To: Essex A North Lot Solar Project File

Memorandum

Project #: R058972.001

Re: Supplement to the Section 248 Natural Resources Assessment

Not Approved for Construction
Drawing Title
Wetland Impact Exhibit

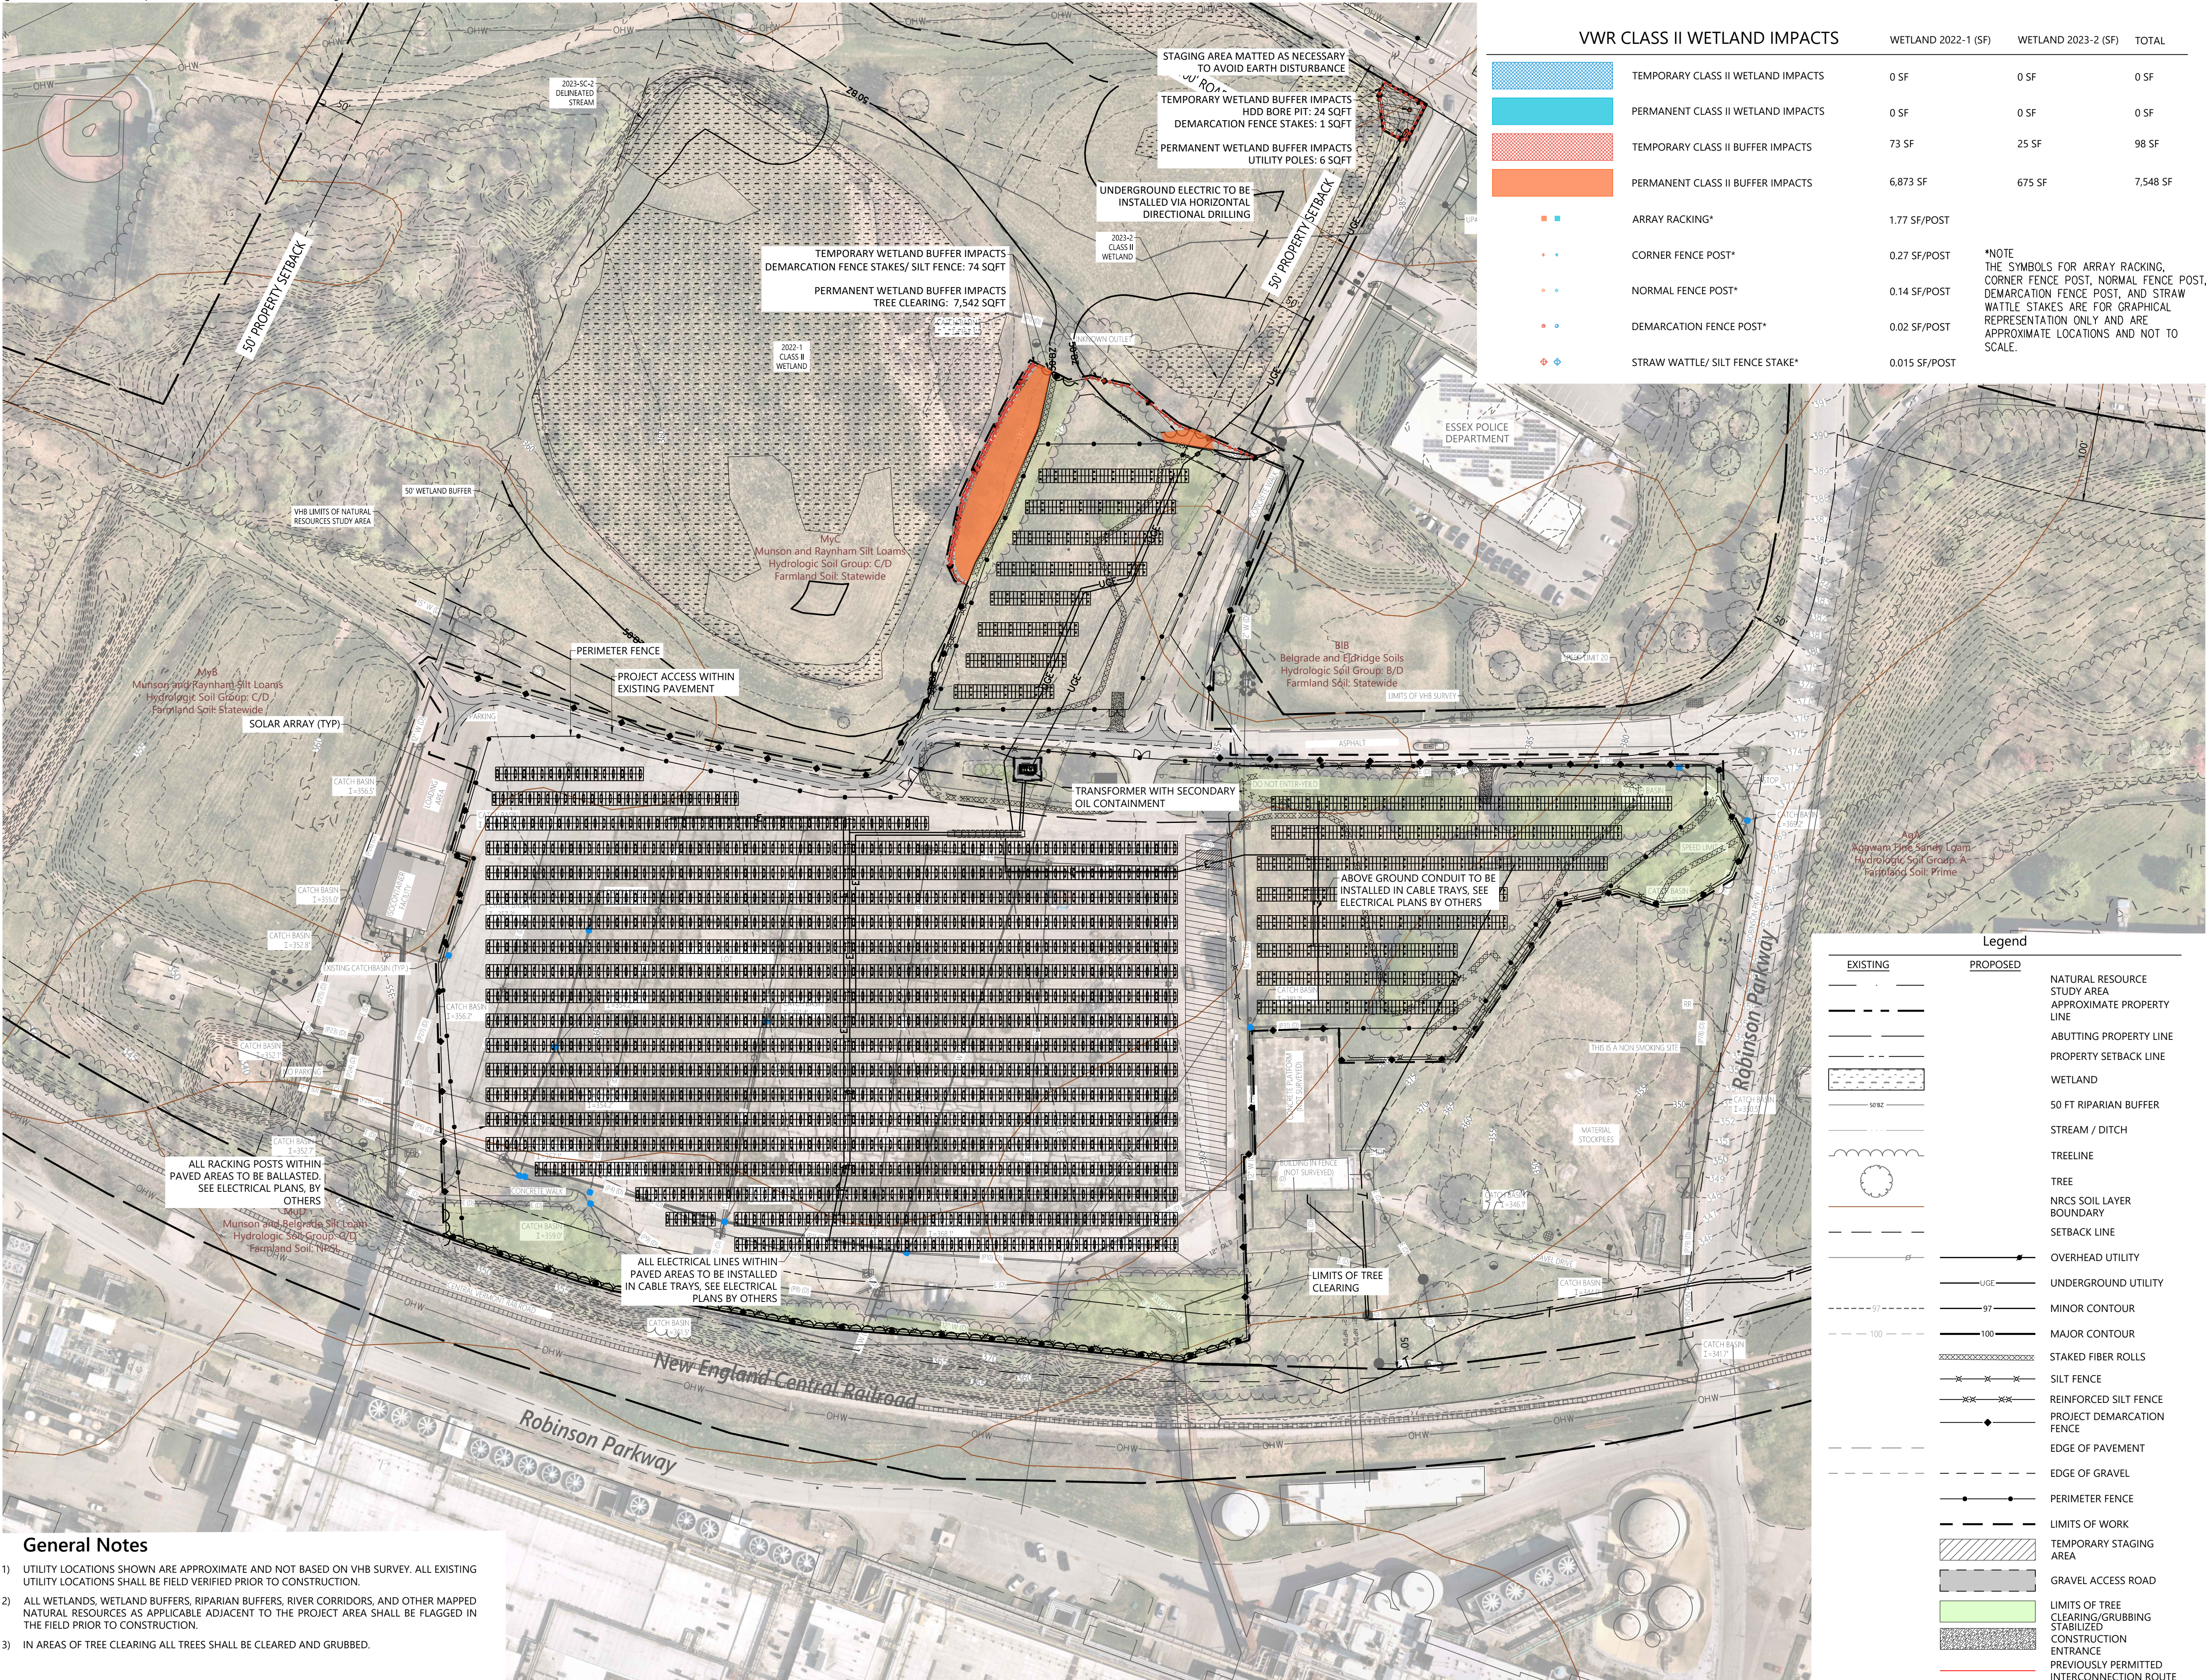
- The approved interconnection route consisted of utility poles and overhead wires running from the POI to an existing pole tie-in, where it would then be buried. The majority of the interconnection route will now be installed underground by horizontal directional drilling ("HDD") running southwest from the intersection of Maple Street and the police station driveway toward the solar array. HDD is considered a Best Management Practice ("BMP") technique to avoid VWR impacts. Revised impact to accommodate the HDD will consist of a 24 square feet, 4-foot deep pit within Class II wetland buffer at the north end of the bore and will be captured in the VIWP minor amendment request, as shown on the revised plans in Attachment 1. The installation is

- The approved overhead line required four new utility poles in a new overhead line corridor within portions of wetland buffer, running along the west side of the police station driveway,. The revised HDD route requires two new utility poles in the wetland buffer, located in roadside locations at the southwest quadrant of the intersection of Maple Street, and the use of the HDD technique avoids any tree clearing in wetland or wetland buffer during installation or operation of the line.

- The POI changed from the existing pole, between the array and the southernmost existing utility pole outside of Class II area, to an existing pole at the southeast quadrant of the Maple Street/police station drive intersection to the existing pole in the northwest quadrant (opposite side of the Maple Street). This existing pole that will be the new POI is beyond VHB's limits of resource investigations; however, the existing pole will be replaced in-kind, which is considered an Allowed Use under Section 6.22 of the VWR and therefore will not require further wetland study or VWIP coverage.

Project modifications in Class II wetland buffer area will not begin until the VIWP has been reissued to authorize the revised impacts. The Project anticipates submitting the VIWP minor amendment request to the DEC in mid-May 2026. The Project changes will result in a reduction in impacts to impacts to wetlands which were already permitted and not undue and therefore do not raise a significant issue and will comply with the VWR.
